## Minor Plat – Reyes Estates (PLAT-25-0091)

### DEVELOPMENT REVIEW COMMITTEE (DRC) PROJECT STATUS REPORT

Date: 10/27/2025  
Project Number: PLAT-25-0091  
Project Type/Name: Minor Plat of Reyes Estates  
Applicant: Brenda DuVerney, High Tide Land Surveying, LLC  
brenda@hightidesurveying.com  
(281) 554-7739  
Planning Contact: Vince Hustead  
[vince.hustead@leaguecitytx.gov](mailto:vince.hustead@leaguecitytx.gov)  
(281) 554 - 1079  
1<sup>st</sup> Submittal Date: August 14, 2025  
2<sup>nd</sup> Submittal Date: N/A

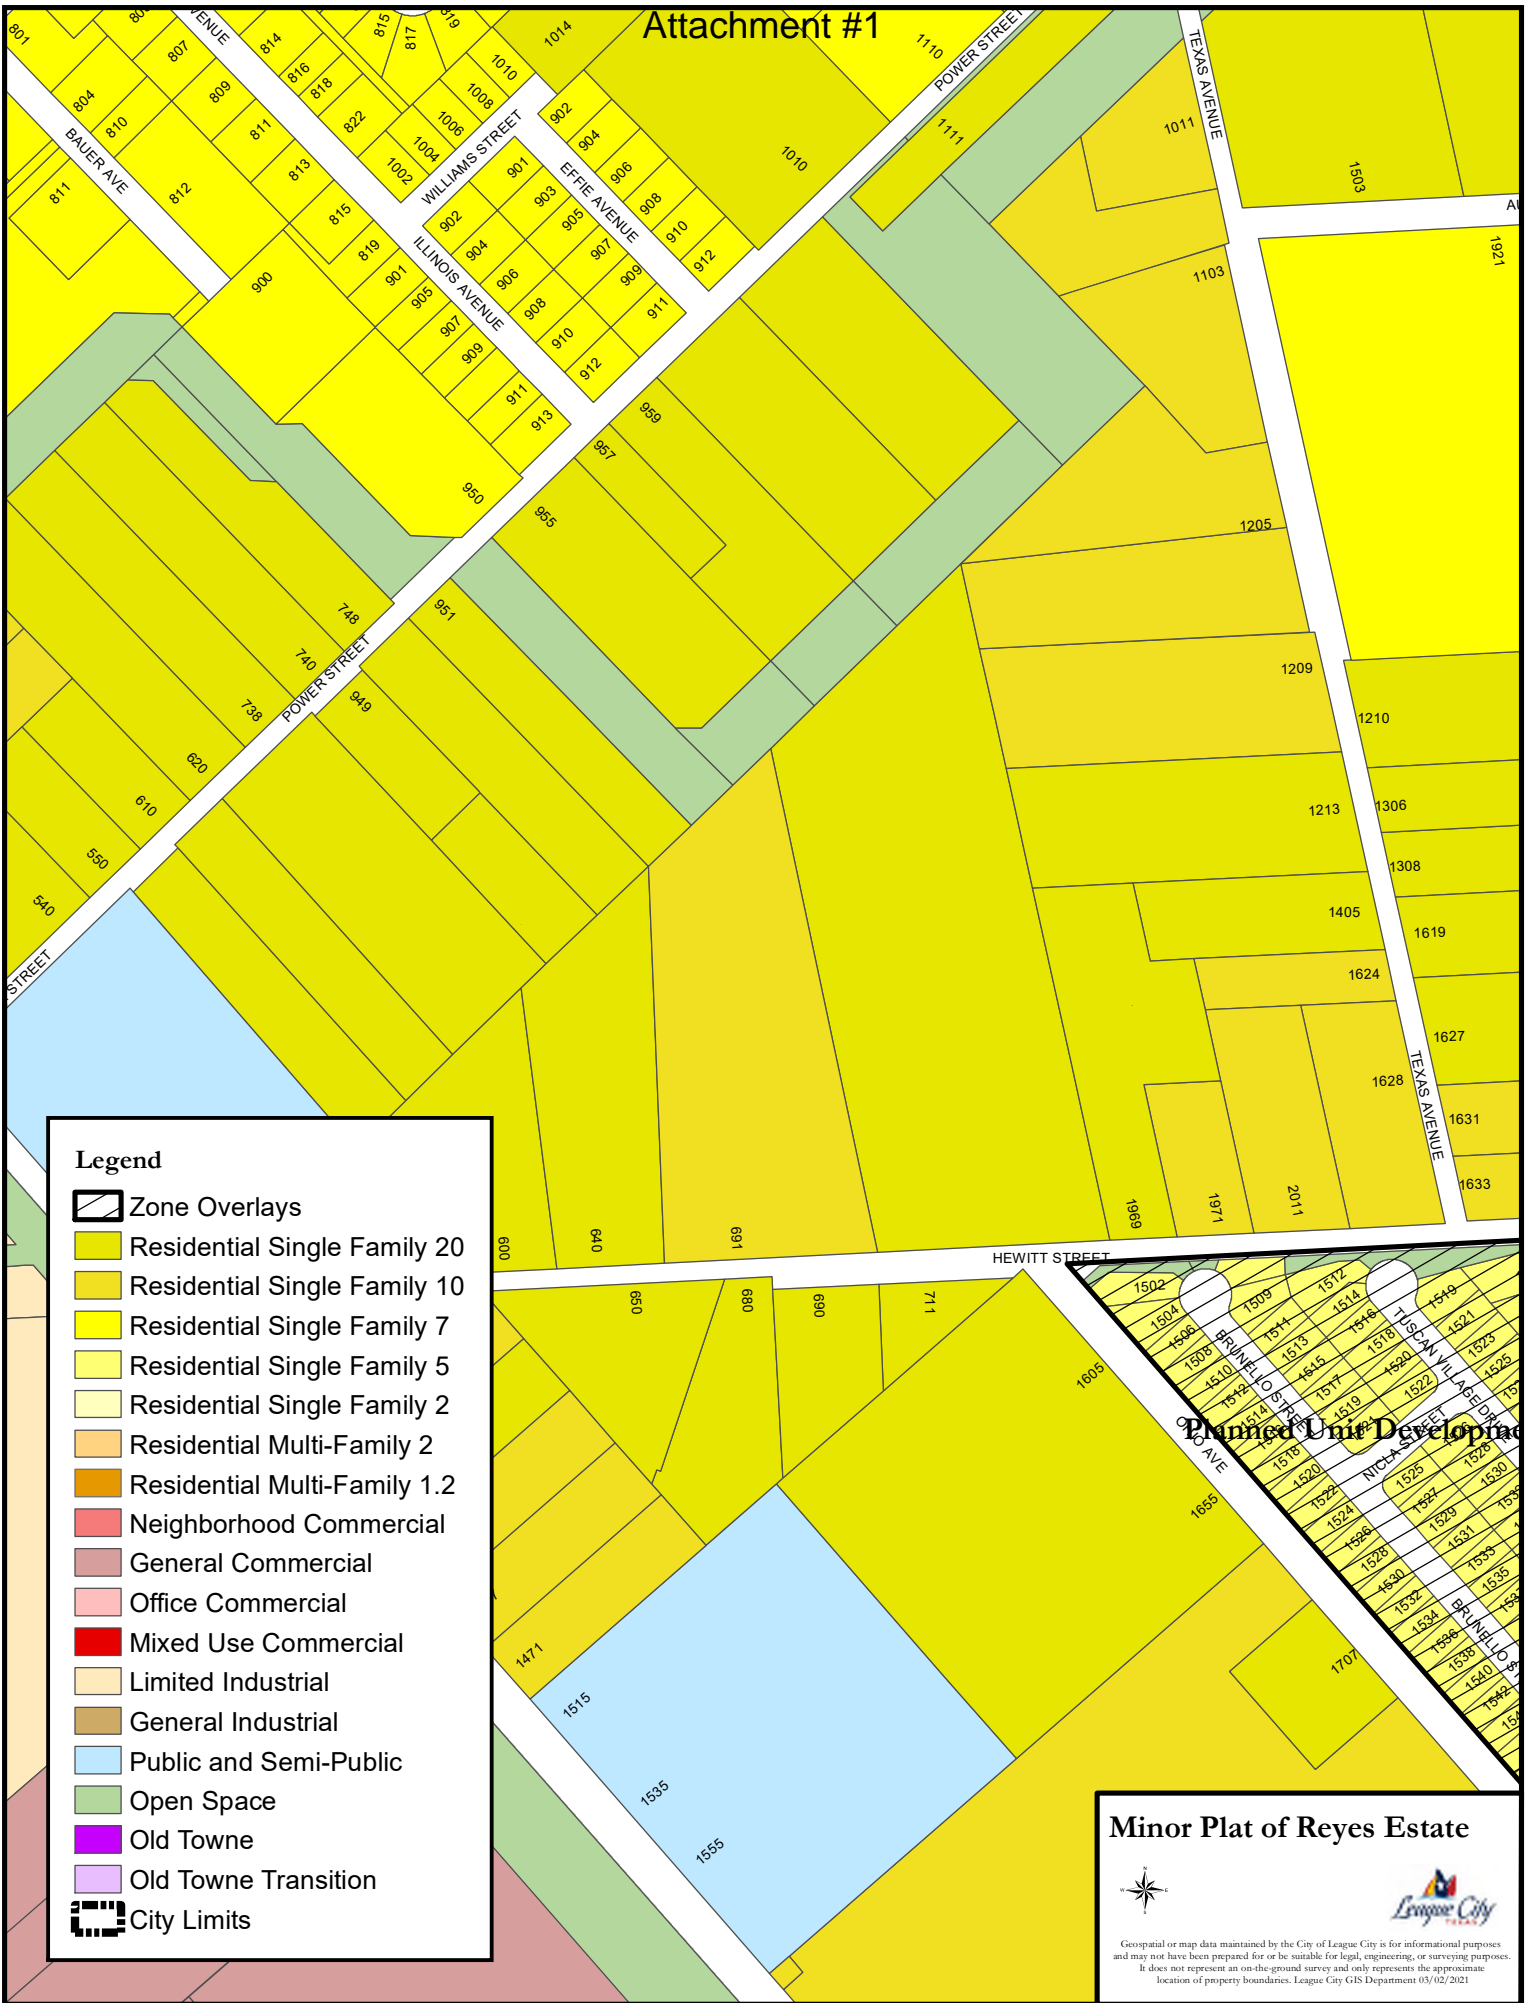
*Staff finds that the plat does not conform to the City's drainage standards in the General Design Standards and the Unified Development Code. The open channel that crosses the property functions as the site's drainage outfall and must include an easement encompassing the channel and adjacent area necessary for maintenance access. During an earlier submittal that was later withdrawn, staff discussed a reduced-width easement as the minimum area needed to satisfy City standards and agreed that routine access would be limited to maintenance or emergency situations. The owners indicated a willingness to maintain the ditch; however, a recorded easement or plat dedication remains necessary to ensure lawful drainage conveyance and maintenance access if ownership changes.*

*The plat does not conform with Unified Development Code. The required drainage easement represents the minimum area necessary under City standards to ensure lawful drainage function and maintenance access and is proportionate to the drainage impacts associated with this development.*

*Staff finds that the plat does not conform with Sections 5.4.2, 5.5.1(b), and 5.9.3.h.10 of the UDC.*

Staff recommends that the Commission affirms the denial of the plat because it omits the drainage easement required by the City's adopted design standards and Unified Development Code. The easement width reflects the minimum area necessary to provide maintenance access and preserve drainage capacity. This recommendation is based on the uniform application of adopted regulations and protection of existing drainage infrastructure, not on any discretionary or project-specific exaction. In addition, other plat discrepancies are indicated in Attachment #4, the DRC Project Status Report (DRC Letter).
